RE: Village Hall and Site Construction, EN2104 & EN2105– Request for information

Thank you for your interest in the Village's project. Highlighted responses to requests for information are listed below. Please note the list is a compilation of questions submitted from multiple Contractors and Suppliers.

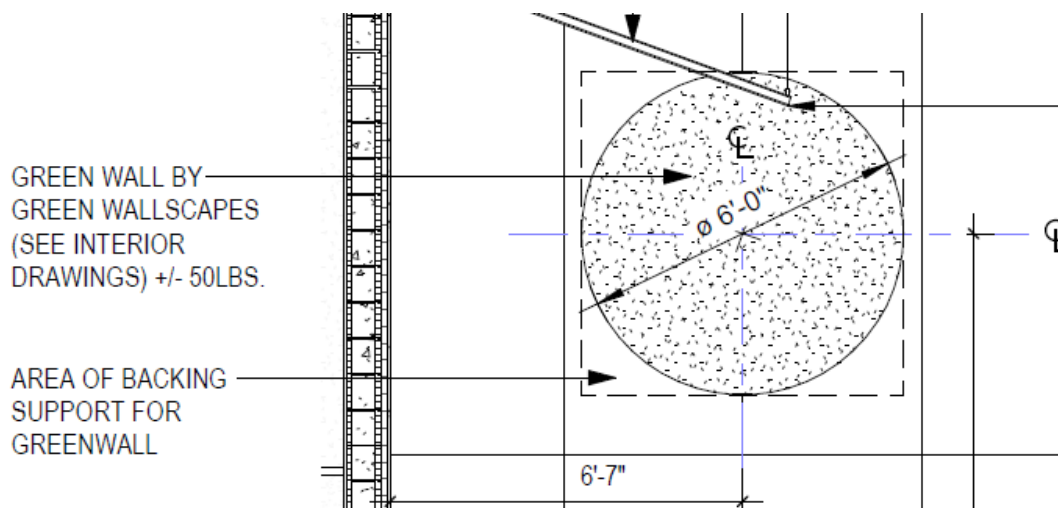
Q. Can you tell me where to find additional/detailed info on the Green Wall, details of the circled area in drawing A-4.50? it is the one with the section: 4 Main Lobby (127) Elevation 3

As stated in the drawings, the green wall feature is provided by Green Wallscales. These items are all custom made by the company for the customer as an "art" piece. Our Interior Designer contacted the company and obtained the below quote for informational purposes. It is a 6'-0" diameter preserved moss and fern, circled-shape installation. The attached document does not constitute the final price for the item, it was obtained for informational purposes. The final piece may vary slightly in appearance from that shown in the attached picture. Bidders must contact Green Wallscales (contact information attached in quote) for additional information regarding delivery and installation of item. Drawings call for backing behind wall in this location as we were informed that the piece can weigh up to 50 lbs.
